Access Compliance Report

Public Rights-of-Way

Intersection ID: 7460	Main Street: FINCASTLE_CT	Cross Street: SILCHESTER_LN	Location:	E
ADA ID: E920C47452E3	Ramp Type: Perp	Initial Pass/Fail: Fail	Overall Compliance: No	Severity Score: 1.25

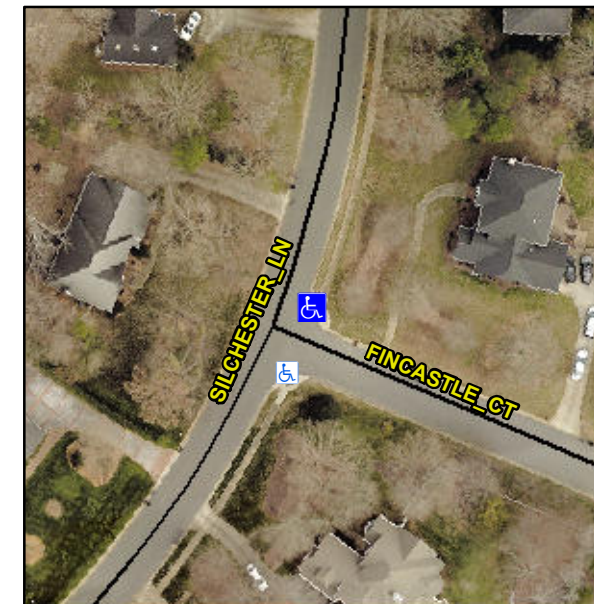
Not Found, R304.5.3

Compliance	Description	Data	Compliance	Description	Data
N/A	Ramp Length (in)	29.0	Yes	Ramp Slope (%)	5.7
Yes	Ramp Width (in)	48.0	No	Ramp XSlope (%)	3.5
N/A	Flare Type LT	N/A	N/A	Flare Type RT	N/A
N/A	Flare Slope LT (%)	N/A	N/A	Flare Slope RT (%)	N/A
N/A	Flare Traversable LT?	N/A	N/A	Flare Traversable RT?	N/A
N/A	Landing Length (in)	N/A	N/A	DWS Provided?	N/A
N/A	Landing Width (in)	N/A	N/A	DWS Contrast?	N/A
N/A	Landing Slope (%)	N/A	N/A	DWS Length (in)	N/A
N/A	Landing X Slope (%)	N/A	N/A	DWS Full Width?	N/A
N/A	Landing Curb? (Y/N)	N/A	N/A	DWS Offset (in)	N/A
N/A	Shared Landing?	N/A			
N/A	Gutter Ponding?	N/A	N/A	Gutter Slope (%)	N/A
N/A	Gutter Lip Ht (in)	N/A	N/A	Gutter X Slope (%)	N/A
N/A	Painted X Walk1?	No	N/A	Painted X Walk2?	N/A
	X Walk 1 Direction	To S		X Walk 2 Direction	N/A
N/A	X Walk 1 Width (in)	N/A	N/A	X Walk 2 Width (in)	N/A
	X Walk 1 Slope (%)	1.5		X Walk 2 Slope (%)	N/A
	X Walk 1 X Slope (%)	1.7		X Walk 2 X Slope (%)	N/A

Remove & Replace Entire Ramp.
